Planning Applications no. H/2014/0252, /0253 and /0254
Hartlepool Wind Farm

Appraisal
of
Noise Impact Assessment

28th July 2015

Figure 6: Aerial photograph of site
Proposed turbine positions are indicated by red dots.

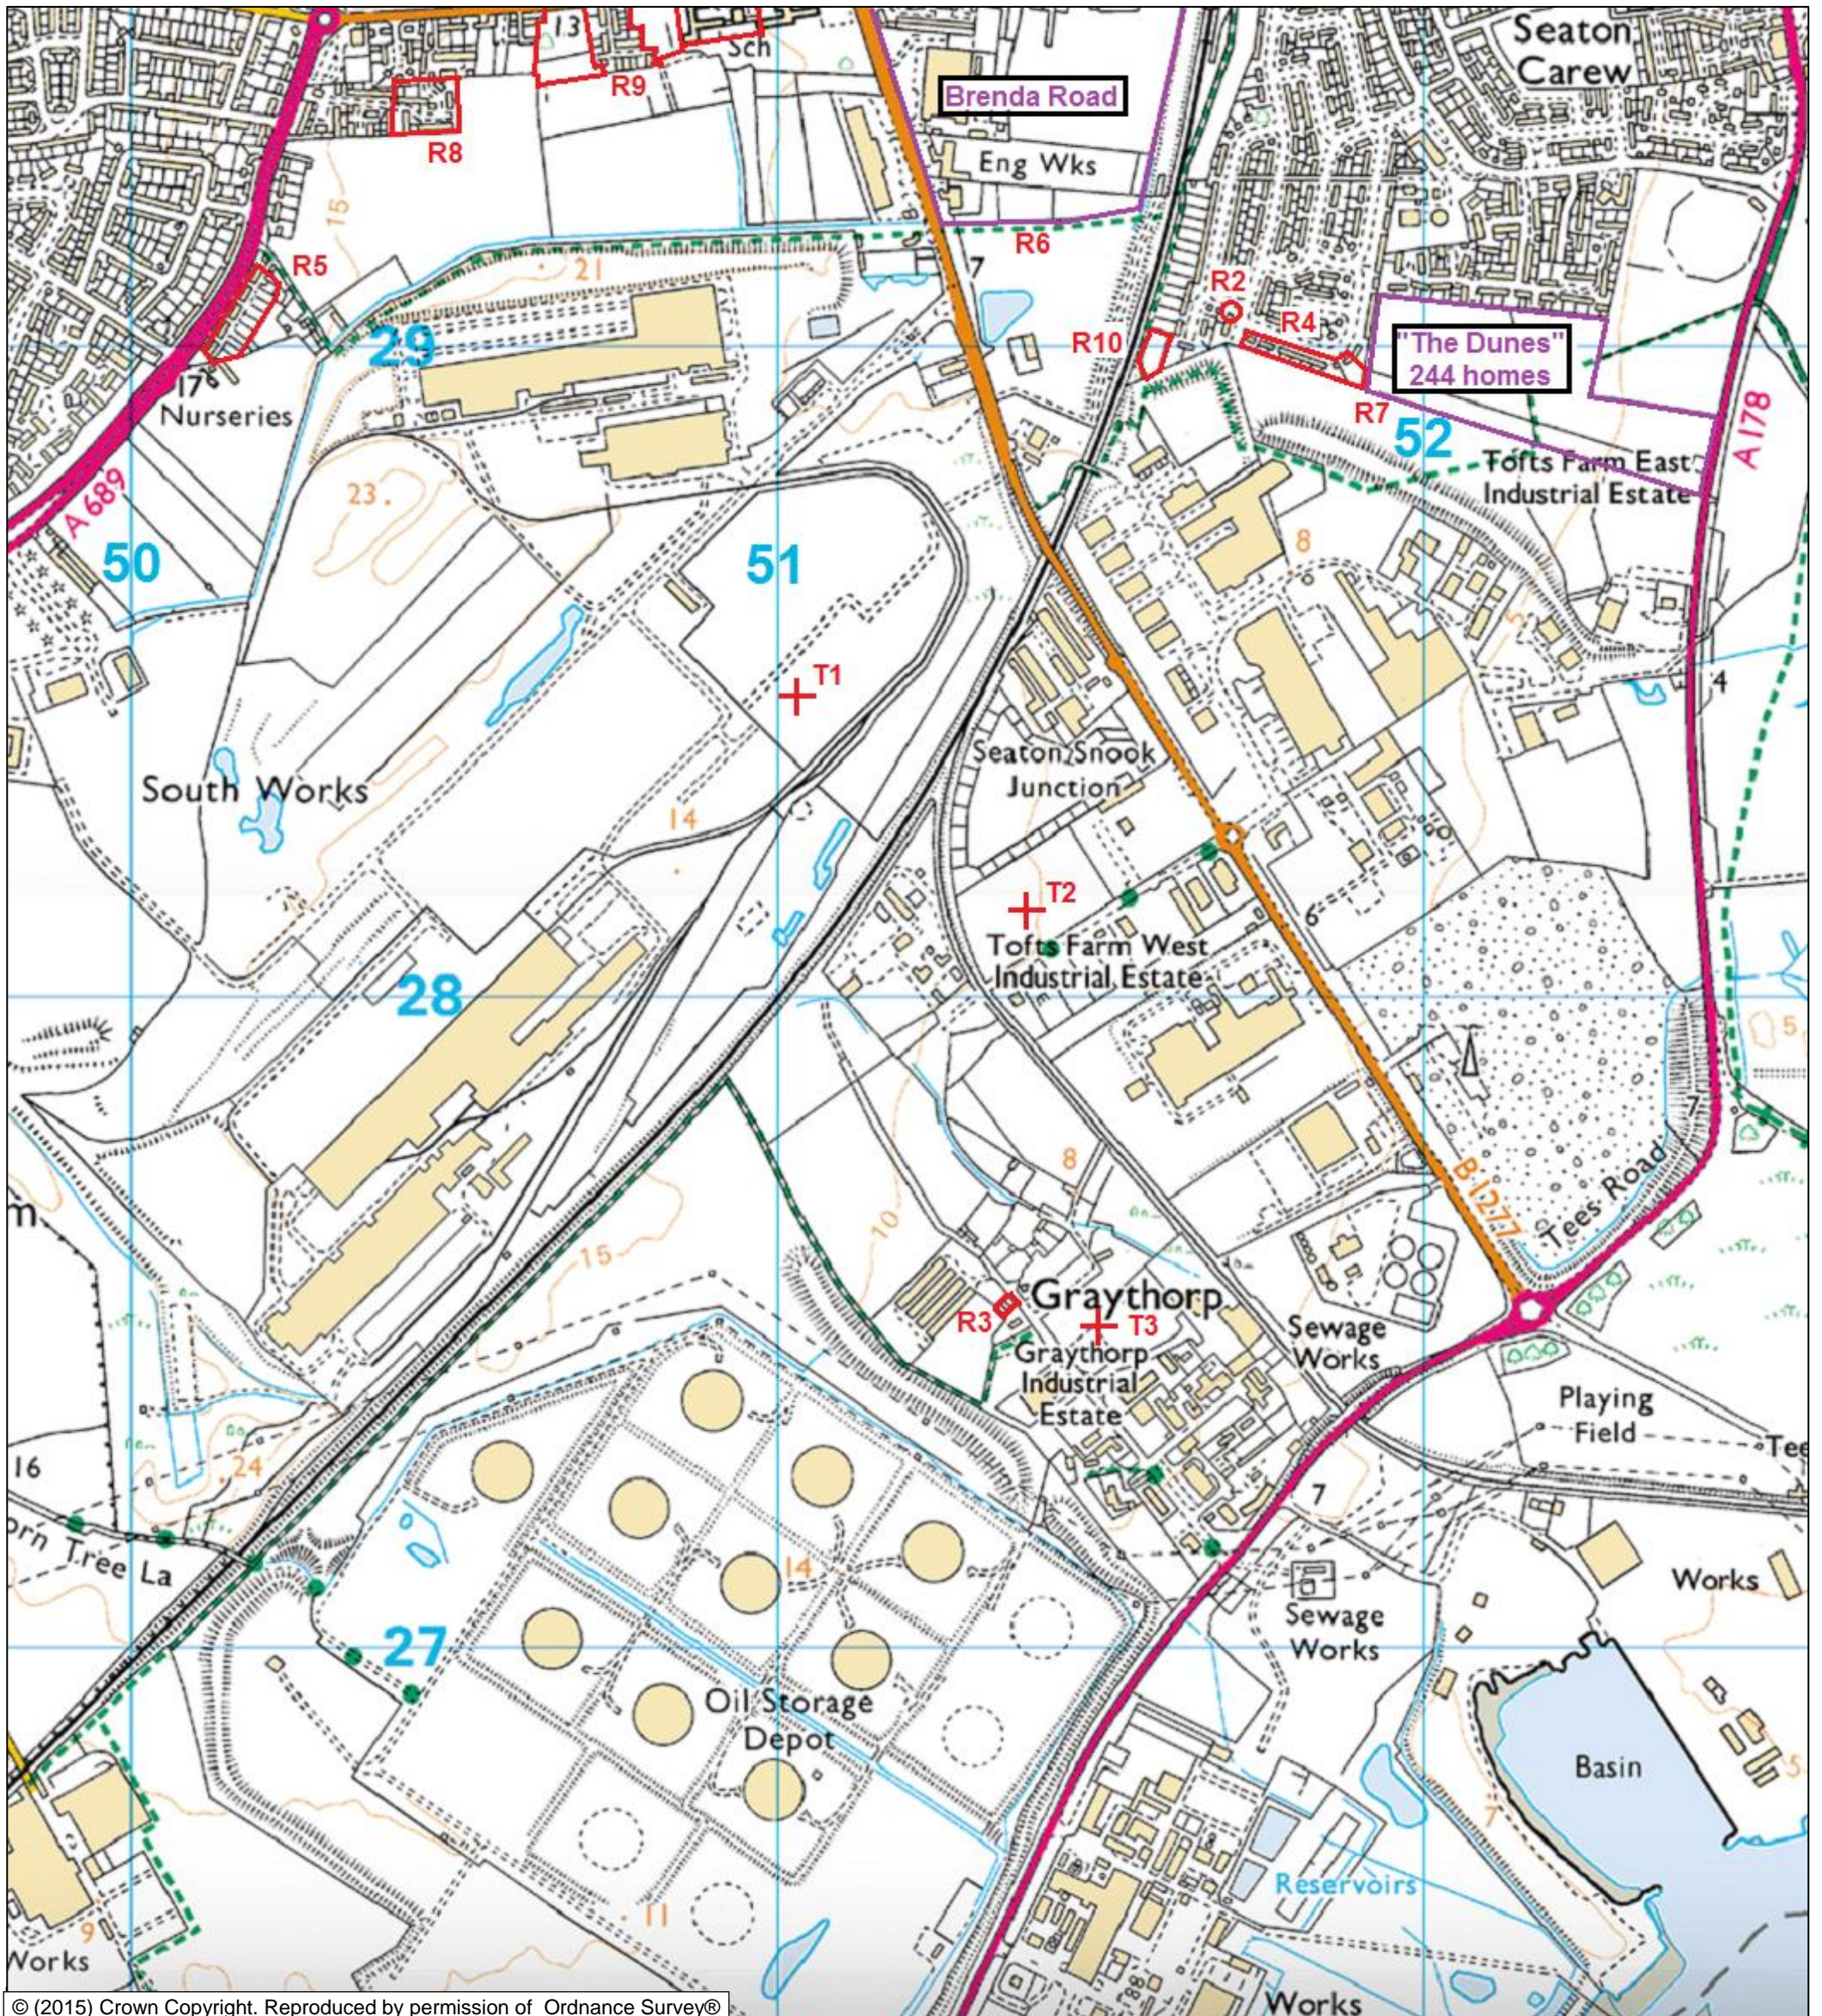
The applicant has not assessed any receptors other than the three selected for background noise surveys. It also appears that no search was made for impacted receptors consented or still in planning. I have made no such search either, but I have in passing come across two developments, shown on the location map (figure 7), at Brenda Road and The Dunes. The latter would be the most impacted of the two. It is for 244 homes, which are already well into construction; it is therefore surprising and unfortunate that it was overlooked by the applicant. A plan of the new development is appended to this document as figure 8. The aerial photograph of figure 6 predates the development.

Figure 9: One of the three single turbine noise contour charts initially submitted by the applicant.

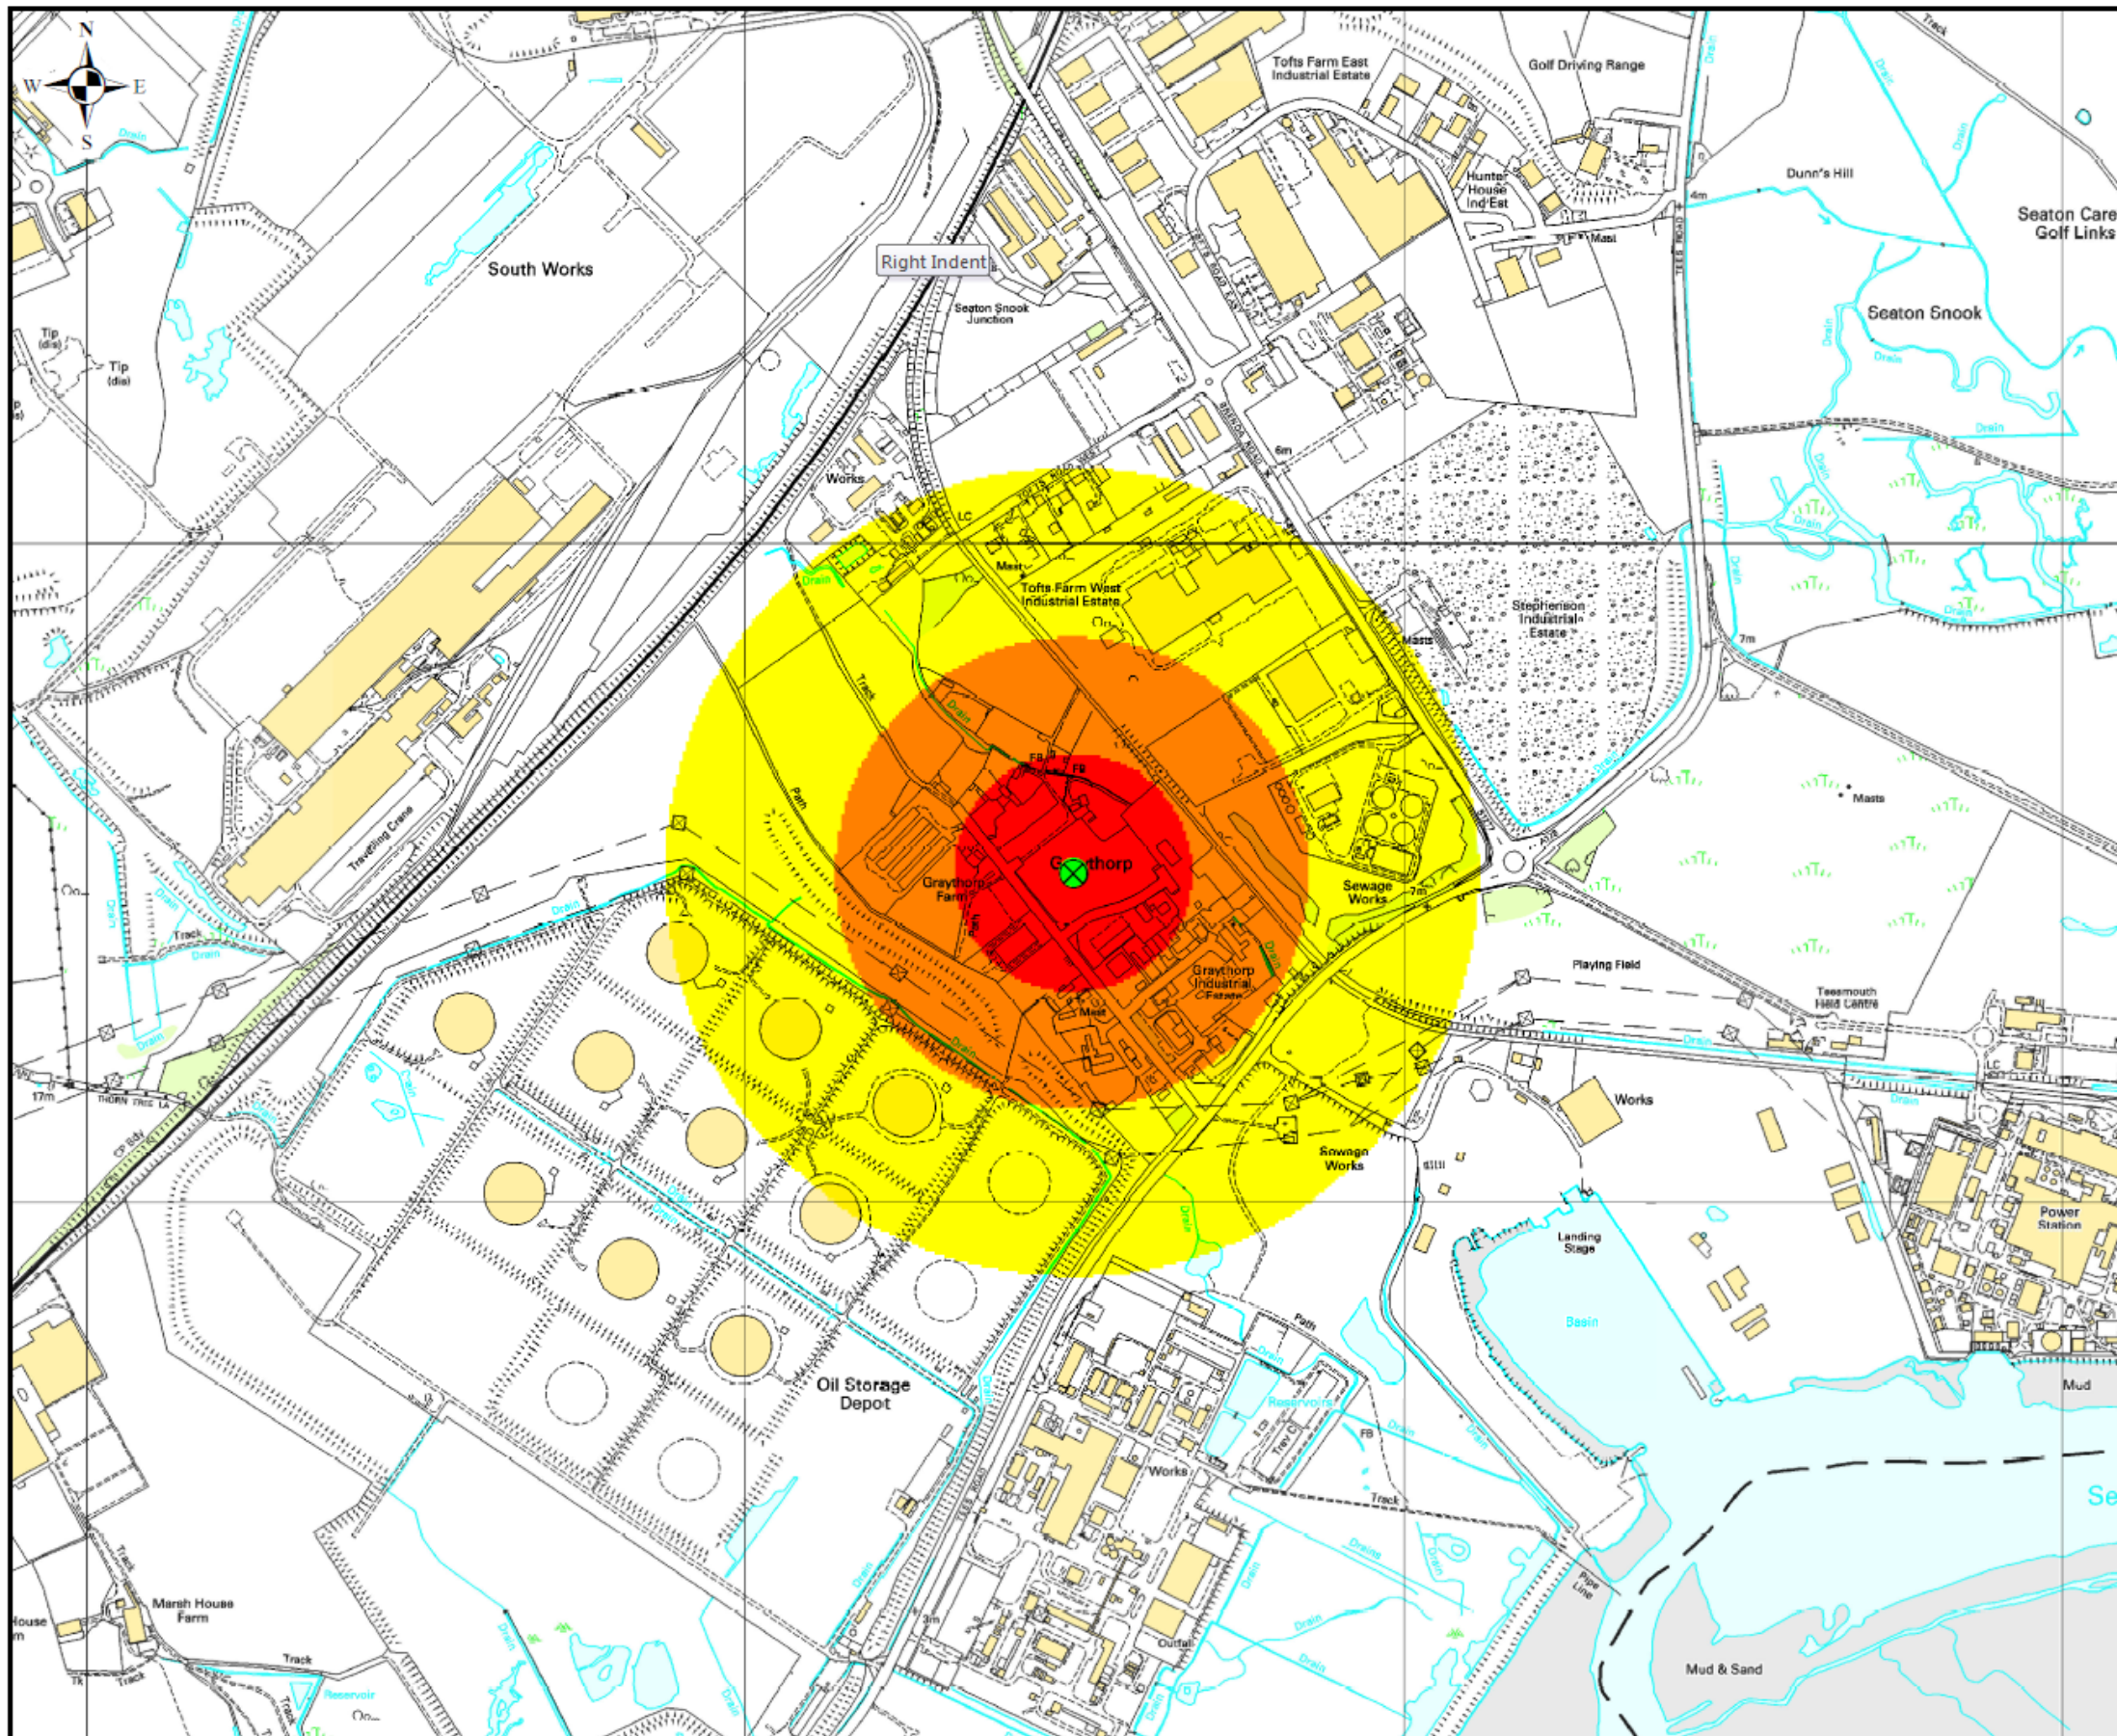
- 4.3.4 The applicant initially attempted to demonstrate noise compliance by submitting separate applications for each of the three turbines, with each application ignoring the presence of the other two turbines (see figure 9). It is to the Council's credit that this was not accepted.
